Luensmann Offsite Water Main Ext PH1
Solicitation Number: CO-00717
Job No.: 23-1043

ADDENDUM 1
11/16/2023

PLAT NO.
JOB NO. 12473-09
DATE MARCH 2023
DESIGNER CD
CHECKED MP DRAWN CD
SHEET C3.07

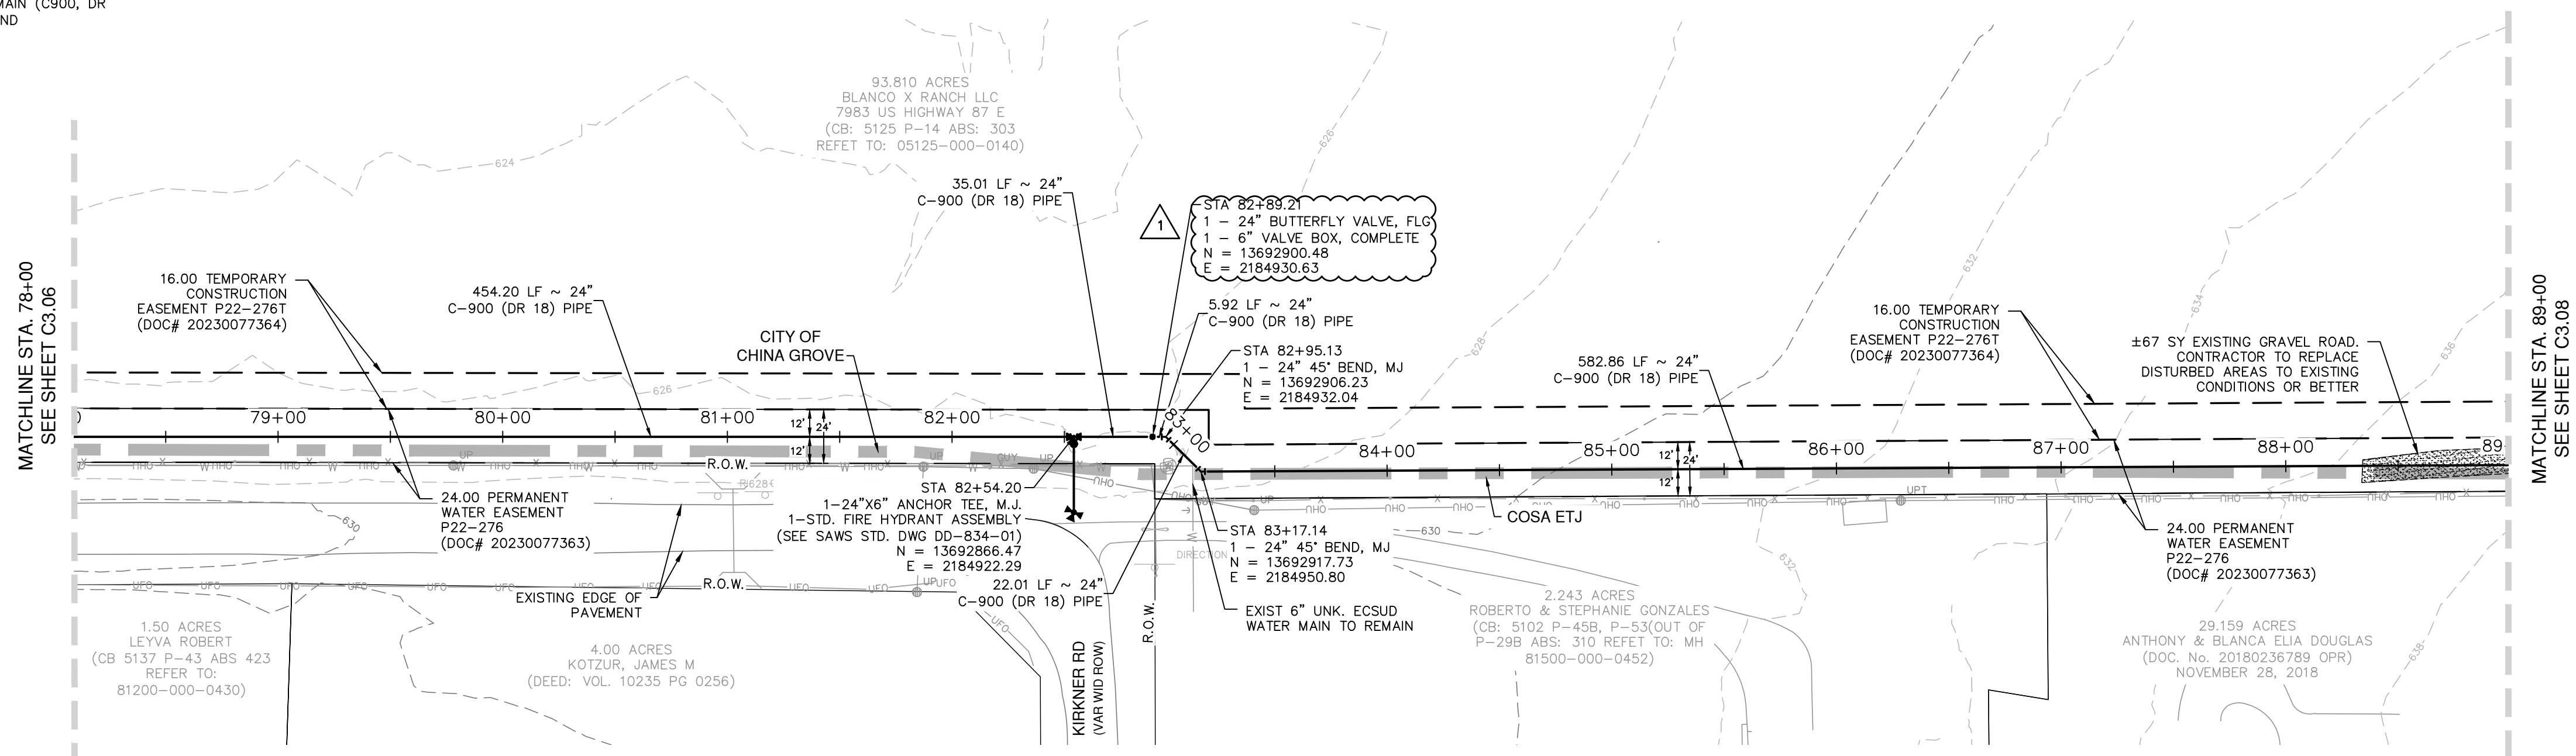
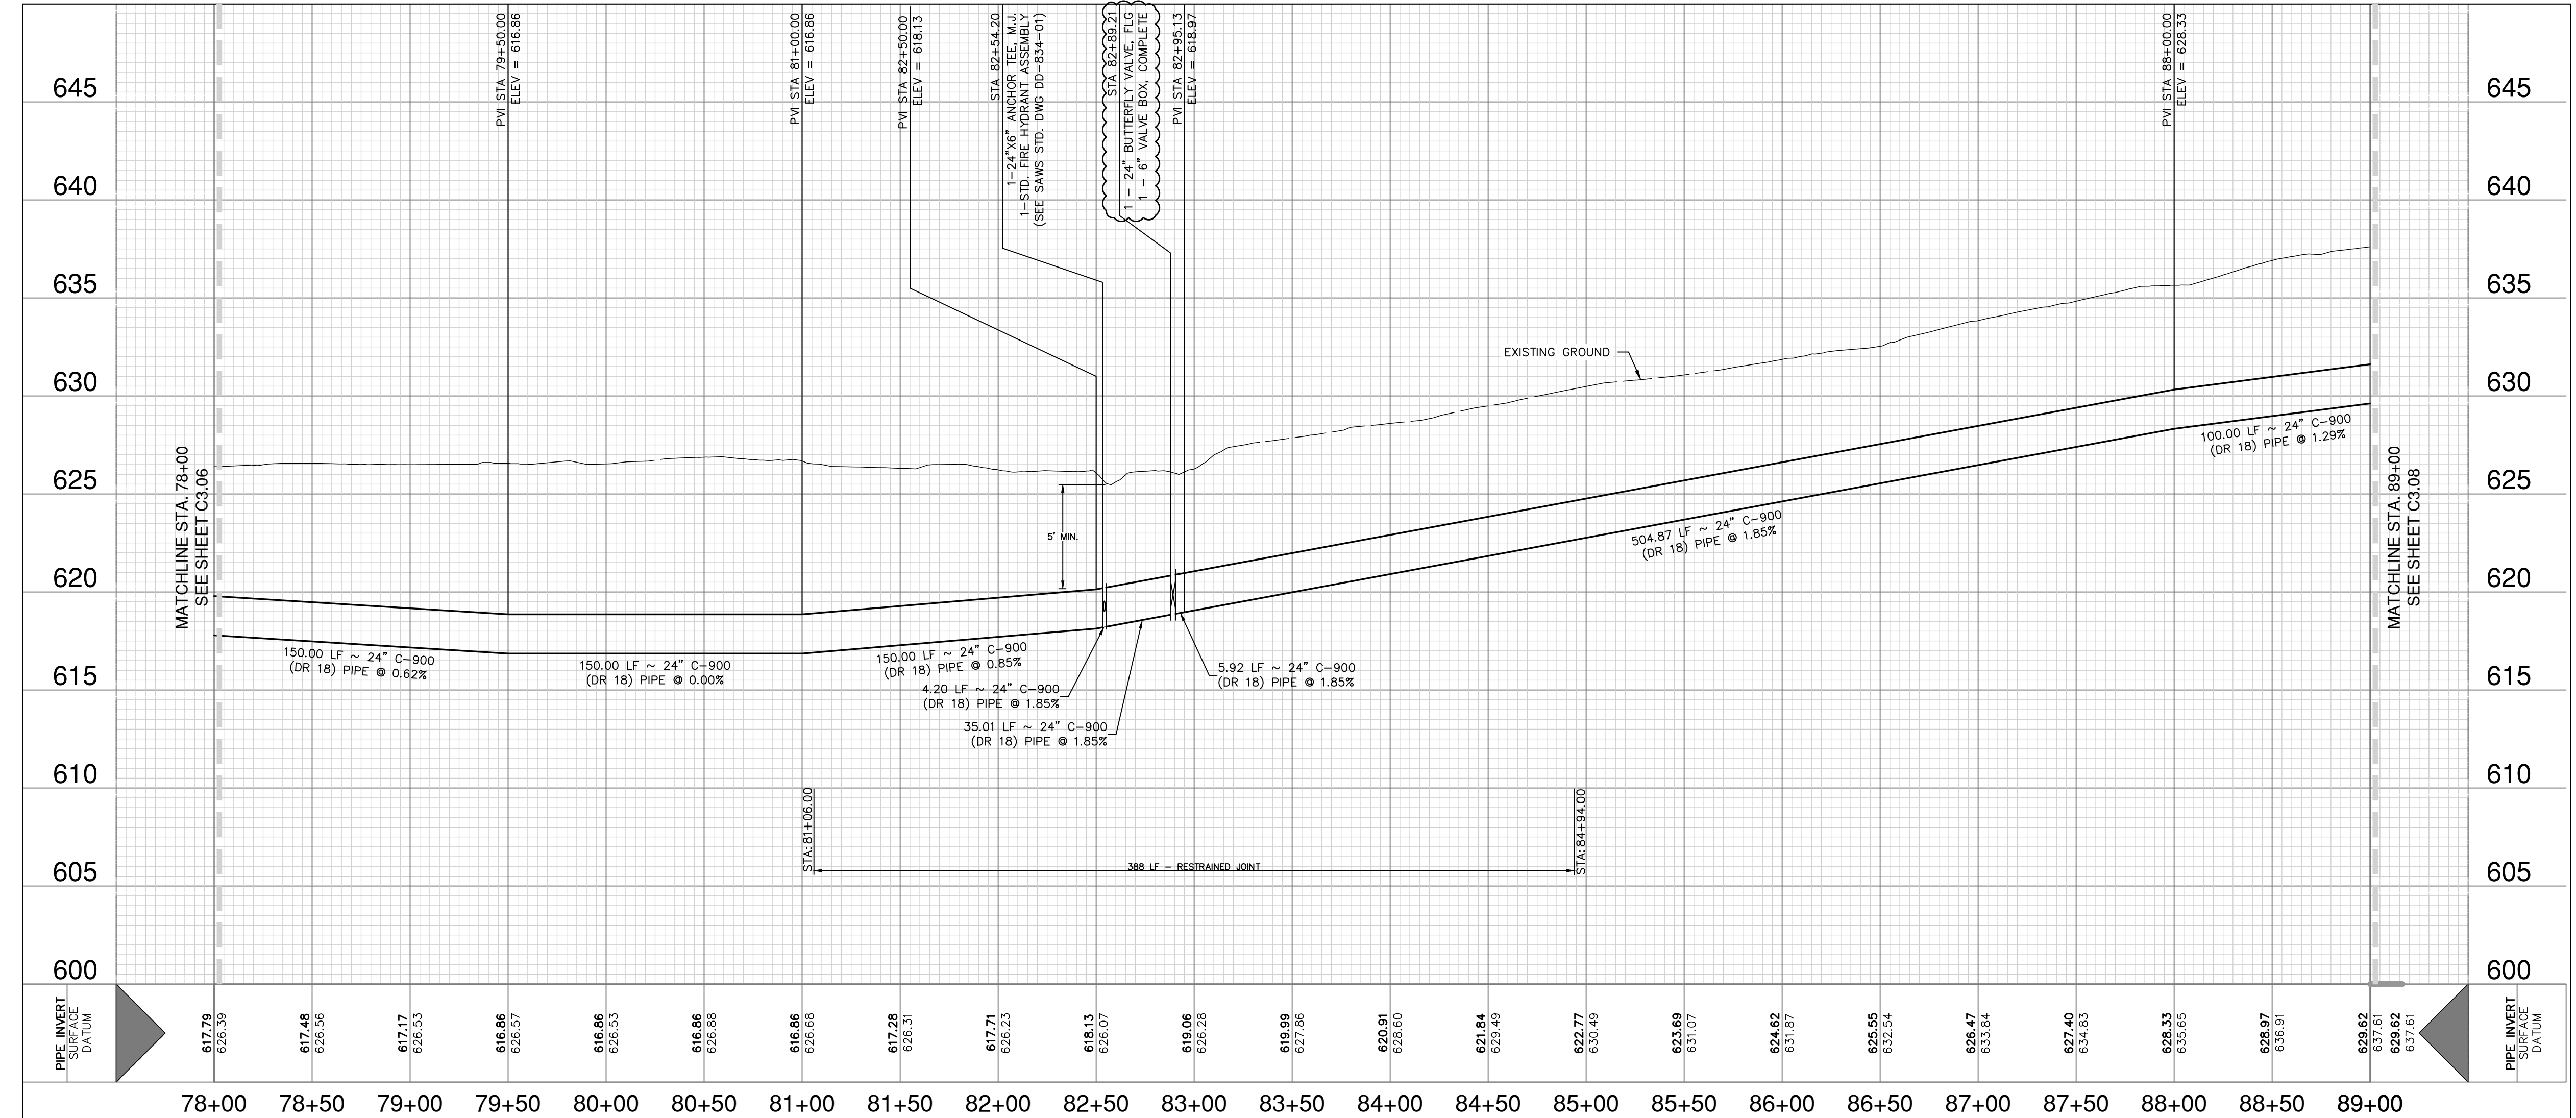
- Revised 24" Butterfly valve to be Flanged.
 9. Sheet C3.07: Water Main Plan and Profile Sta 78+00 to 89+00 – Remove in its entirety and replace with the attached document.

PLAT NO.	
JOB NO.	12473-09
DATE	MARCH 2023
DESIGNER	CD
CHECKED	MP DRAWN CD
SHEET	C3.08

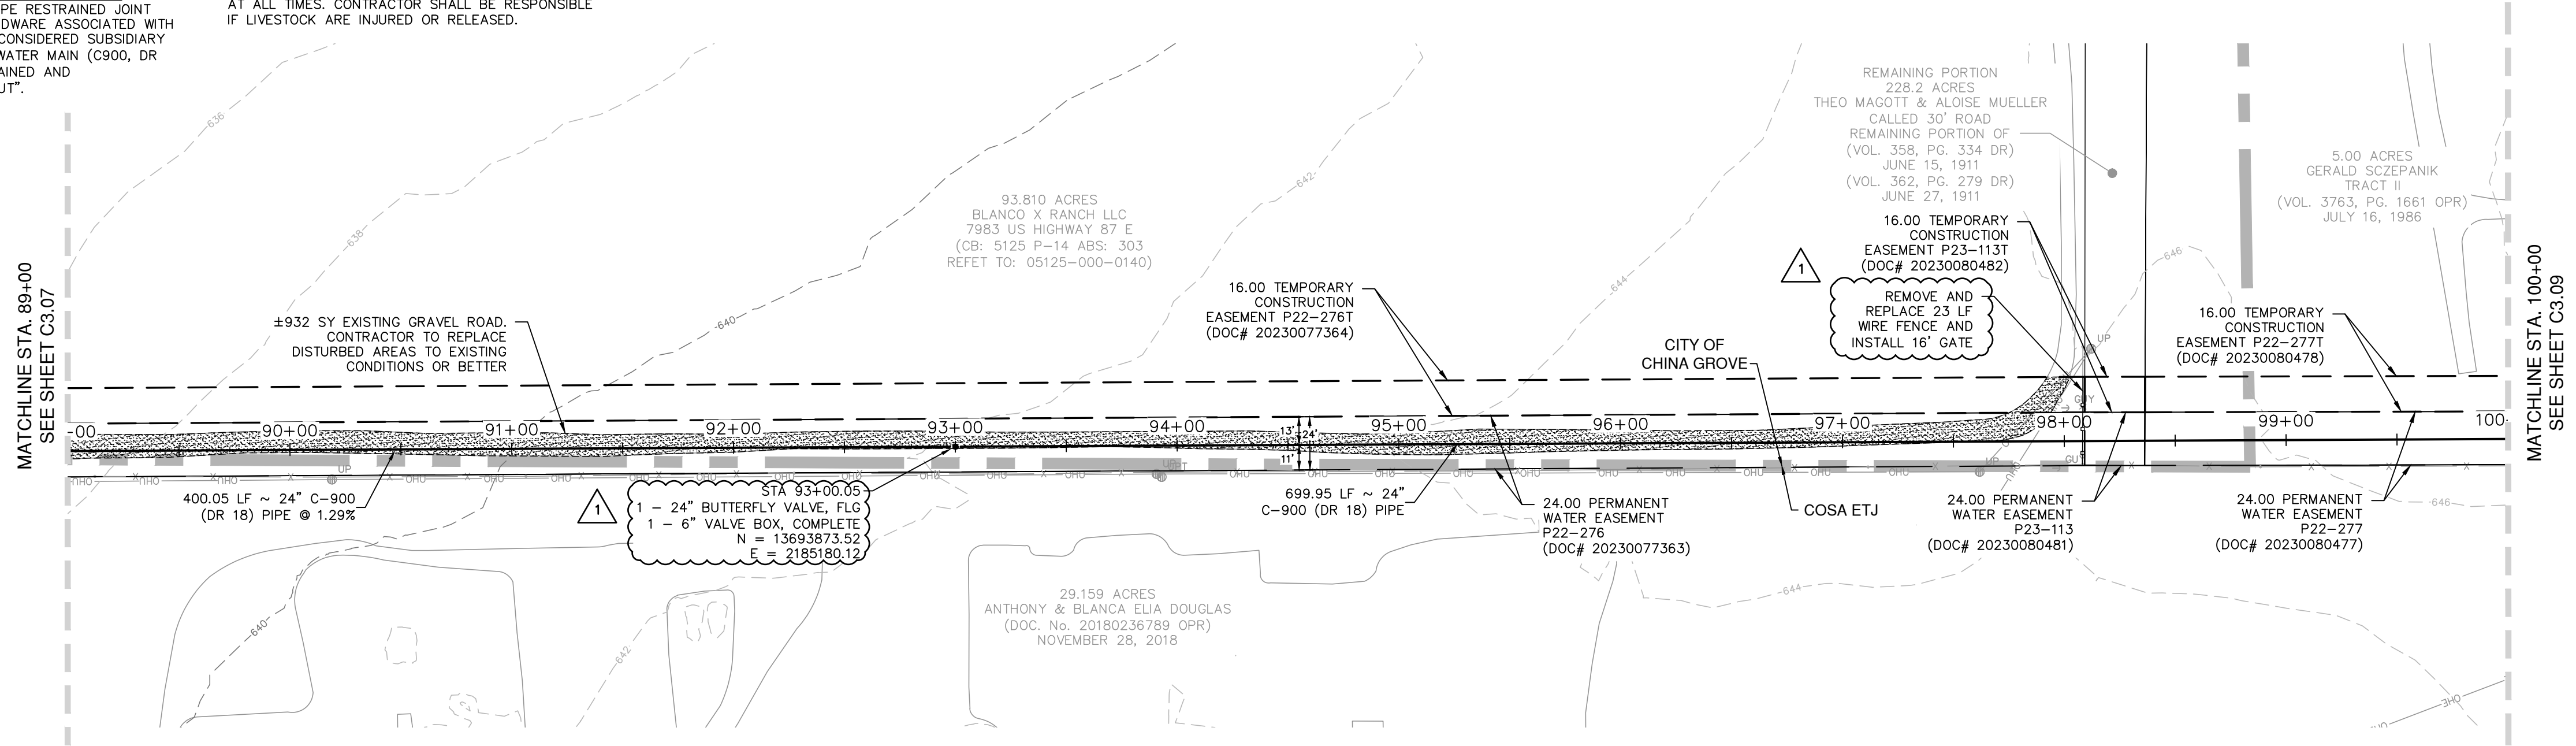
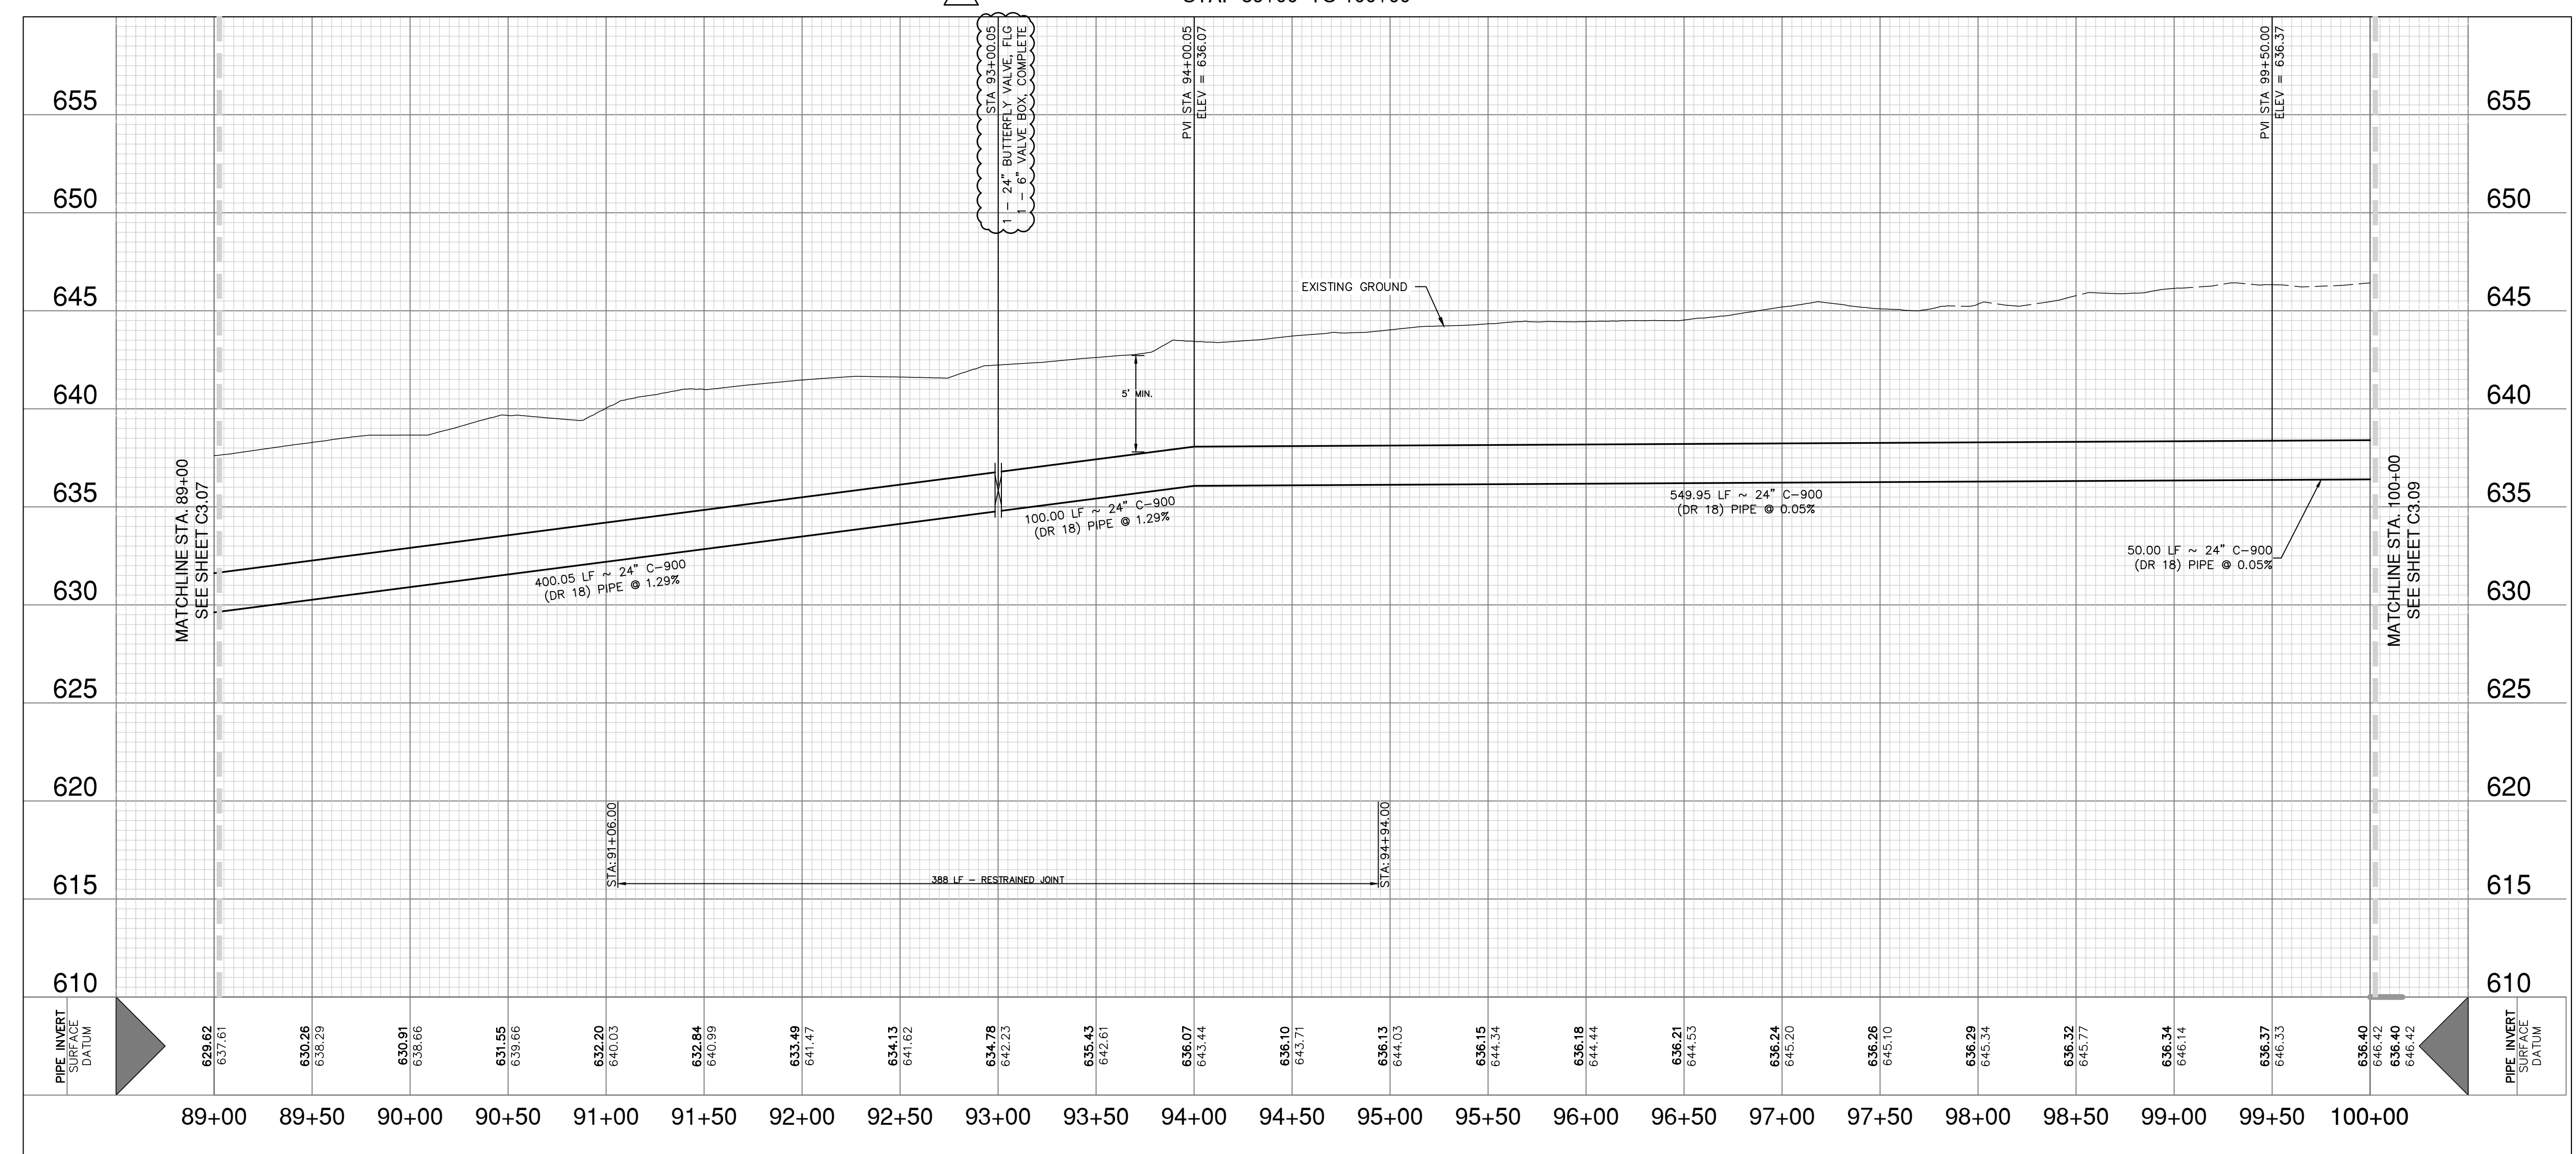
24. **Question:** The water line construction will take up the full width of the existing driveways on sheets C3.08, C3.09, and C3.11. Are there alternate routes the property owners can use during this construction?

- Revised 24" Butterfly valve to be Flanged.
 10. Sheet C3.08: Water Main Plan and Profile Sta 89+00 to 100+00 – Remove in its entirety and replace with the attached document.

Response: Yes, the property owners utilizing the driveways labeled to be replaced on sheets C3.08, C3.09, and C3.11 have alternate routes available to them to access those properties.
